# HISTORIC LANDMARK COMMISSION STAFF REPORT

## Peterson Residence Property Modifications

Major Alterations

PLNHLC2014-00585

**PORCH PLAN**

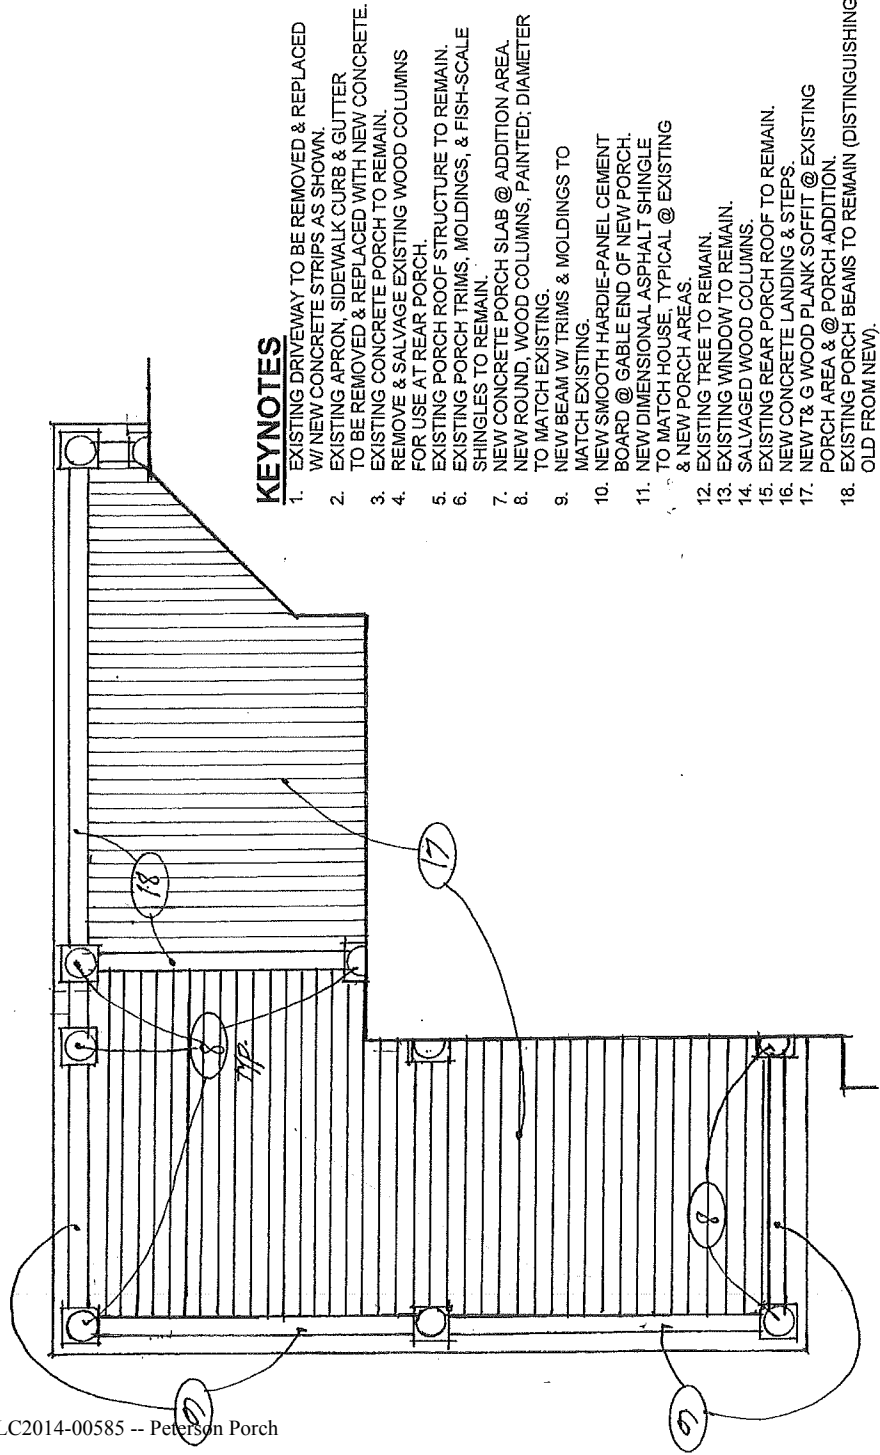
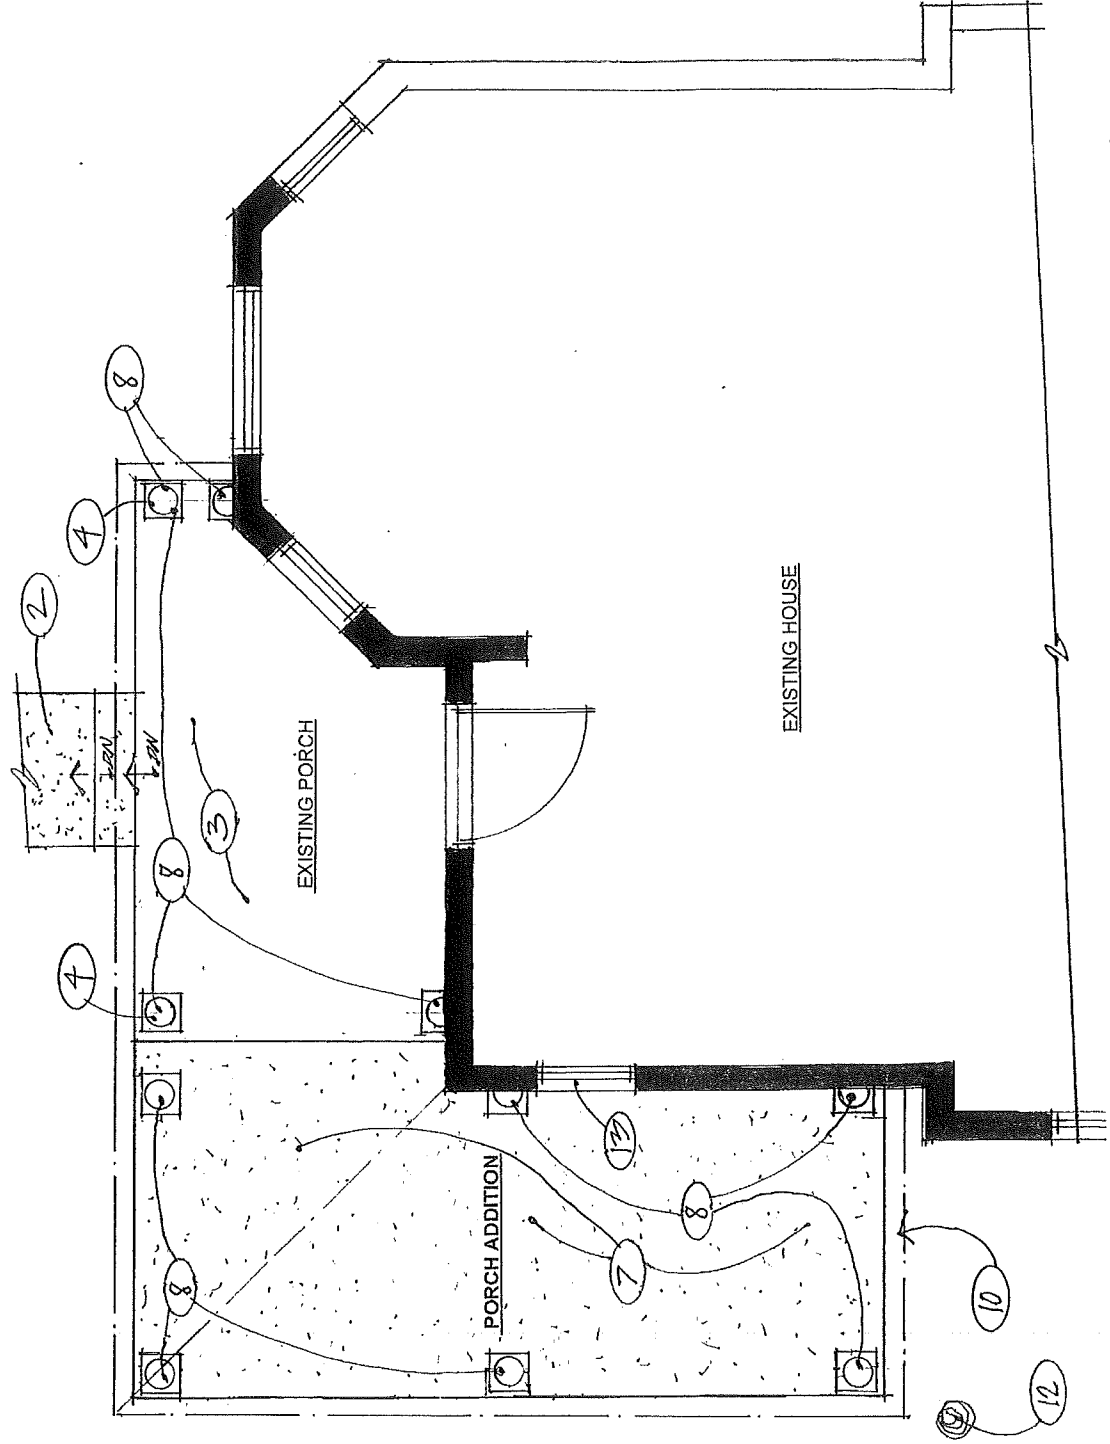
The existing non-original porch columns proposed to be removed and placed at the west side entryway will remain part of the historic character of the property. The new columns on the front porch that will replace these two will be painted wood and will be the same diameter as the existing columns. Staff has determined that the existing columns on the front porch are not original to the structure. When the Reconnaissance Level Survey was done in 1978 for this part of the Avenues Historic District, the researcher noted in the description of the property that the original wood columns had been replaced with wrought iron. Therefore, relocating the existing non-original columns to the west side facing façade helps to retain the historic character of the property. The only other change that will be made to the west side façade entryway is a new concrete landing and steps. The roof covering with the gable shape will not be altered in any manner.

**Analysis:** The applicant has designed the extension with different materials and patterns along the fascia, soffit and porch slab in order to help differentiate it as an addition that is not original to the residence. The asphalt shingles, trims and moldings around the edge of the porch extension are the only two items that will be similar. The remainder will be differentiated with either different patterns or new concrete paving that will not exactly match the original.

**Finding:** The proposed changes reflect the preservation of a majority of the original structure with the exception of the end of the side gable of the existing porch. The existing main residence will remain unaltered. The porch extension is proposed to be supported by the columns and will not need to be structurally attached to the original part of the residence. The roof for the porch extension will have minimal attachment in order to preserve the brick exterior.

**Analysis:** The porch as proposed, for the most part, preserves the majority of the original porch in both form and physical integrity, and if the wraparound porch addition was to be built and subsequently removed, the original structure is relatively unimpaired. The material of the new gable end will be different and the applicant has noted that a new concrete slab will be poured next to the existing to differentiate it from the original.

**NORTH ELEVATION STUDY (FRONT)**

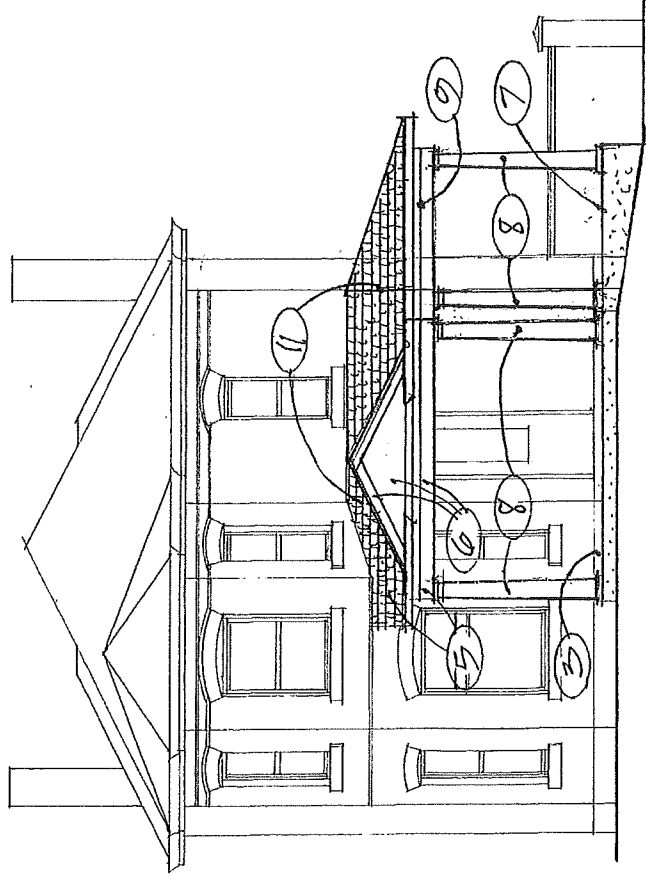
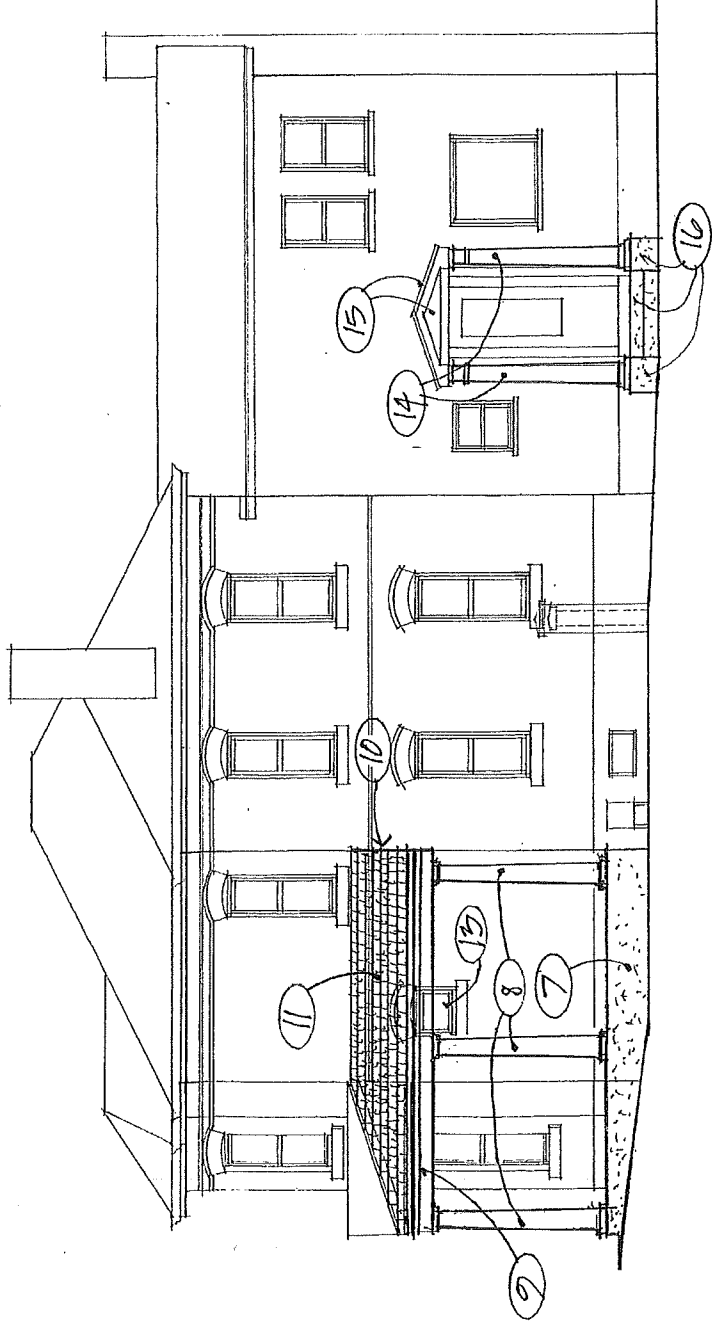
**Analysis:** The home is located in the interior of the block and although the proposed porch extension it will be visible from the public right-of-way, the applicant has made an effort to make the porch extension compatible, yet differentiated from the original construction. In addition to being designed to stand on its own, the extension is compatible with the size and scale of the building and similar to the original porch in materials and design. The materials and roofline are also compatible with the main historic residence. The proposed extension of the porch could be easily removed in the future with little impact the historic residence.

The front porch expansion could have an impact on the appearance and character of the residence but is not likely to affect the historic integrity of the building. The design of the porch has been done in such a manner, and as noted previously, that it can be removed at some point in the future will little impact to the main historic property. The owners of the property would like to have this patio on the front of residence to encourage social activity and interaction with the neighborhood which is a common feature in the Avenue Historic District.

**Analysis:** With the exception of the front porch alterations, no other element of the original structure will be removed or altered. The proposed porch addition is designed in such a manner that it will have minimal effect on the existing brick exterior and is compatible with the size, scale and materials of the existing porch. The proposed porch extension is compatible with the character of the residence and has been designed to maintain and not remove the small window along the west façade. It has also been designed in a manner not to compete with the historic views of the home from the public way thus maintaining the character of the property, neighborhood and environment in a sensitive manner.
